SERVICE DIRECTIVE BULLETIN NO. 0114

1. SUBJECT: Pylon Tube Inspection, P/N 28-11100-71
2. MODEL: F-28A, 280, F-28C, 280C, F-28F, 280F, and 280FX
3. EFFECTIVITY: S/N 829 and prior; S/N 2134 and prior
4. BACKGROUND:

*Figure 1.* This is a drawing model of a partial pylon assembly and P/N 28-11100-71 pylon tube (view looking down). The dashed line along the tube represents the direction of potential tube deflection.

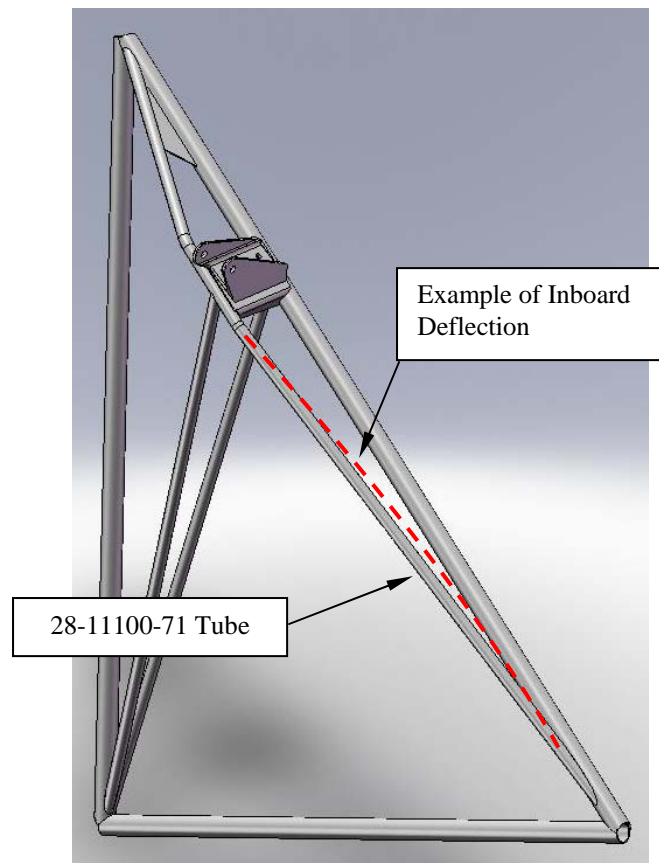
- 6.1 Remove the wraparound cowl or left-hand aft cowl, as applicable.
- 6.2 Inspect the P/N 28-11100-71 tube (*Figure 1*) for bowing. Place a straight edge tool along the outboard side of the tube (*Figure 2*). Any deflection will be observed near the middle of the tube.
  - 6.2.1 If the tube is straight, no additional inspection is required.
  - 6.2.2 If the tube is bowed, measure the deflection at the largest gap between the tube and the straight edge.

- 6.2.3 If the gap measures 0.001-0.179 inch (0.02-4.5 mm), no additional action is required.
  - 6.2.4 If the gap measures 0.18-0.20 inch (4.6-5.1 mm), report the findings to Enstrom Customer Service for statistical data.
  - 6.2.5 If the gap measures 0.20 inch (5.1 mm) or greater, the pylon tube must be replaced. Contact Enstrom Customer Service for repair instructions.
- 6.3 After repair or inspection, as appropriate, re-install the cowling removed in step 6.1 and make a log book entry.
- 7. PARTS: None
  - 8. SPECIAL TOOLS: None
  - 9. MAN-HOURS: Inspection – 5 minutes
  - 10. WARRANTY: Per Enstrom Warranty Policy
  - 11. WEIGHT CHANGE: None
  - 12. LOG BOOK ENTRY:  
Record this inspection or modification in detail as required for maintenance actions.
  - 13. REPETITIVE ACTION: None
